Panel Reference	PPSHCC-298
DA Number	DA/2024/424
LGA	Maitland City Council
Proposed Development	Educational Establishment (School) with construction of a Multi-Purpose Centre, refurbishment of St Paul's Parish Hall, 4 into 3 Lot Torrens Title Subdivision, Category 1 Remediation Works, Demolition works and Tree Removal
Street Address	20-24 Hunter Street, Horseshoe Bend
Applicant/Owner	Trustees of the Roman Catholic Church for The Diocese of Maitland-Newcastle C/o Barr Planning
Date of DA lodgement	24 May 2024
Total number of Submissions Number of Unique Objections and Summary of key submissions	Two
Recommendation	Approval
Regional Development Criteria	Clause 5(b), Schedule 6 of State Environmental Planning Policy (Planning Systems) 2021: Private infrastructure and community facilities including educational establishments with a EDC of more than \$5 million
List of all relevant s4.15(1)(a) matters	<ul style="list-style-type: none"> • <i>State Environmental Planning Policy (Biodiversity and Conversation) 2021;</i> • <i>State Environmental Planning Policy (Industry and Employment) 2021;</i> • <i>State Environmental Planning Policy (Planning Systems) 2021;</i> • <i>State Environmental P

Figure 3 – Proposed capping for remediation area A

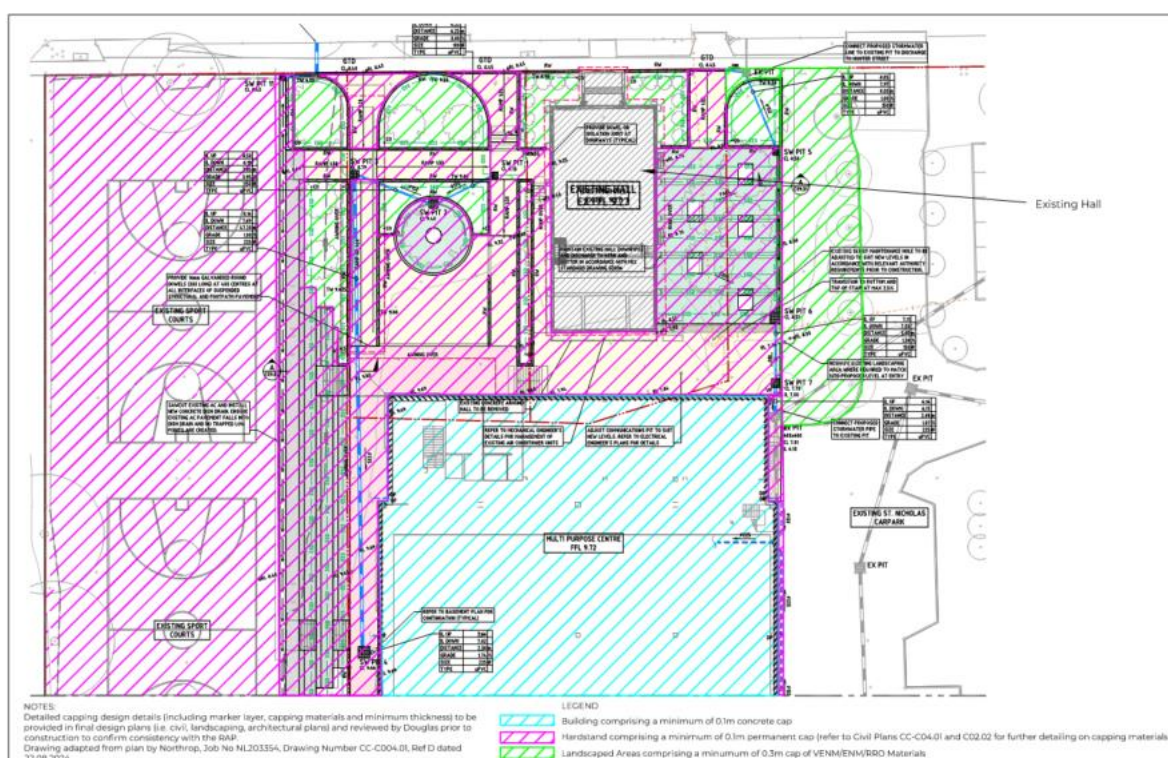
- Remediation Area A (proposed MPC & St Pauls Hall): Onsite management of impacted area beneath the proposed building and associated pavements and landscaped areas (refer to Figure 3 and 4 below);
- Remediation Area B (existing fill mound in the central northern portion): Onsite management beneath an appropriate soil capping. Note to achieve design finish levels
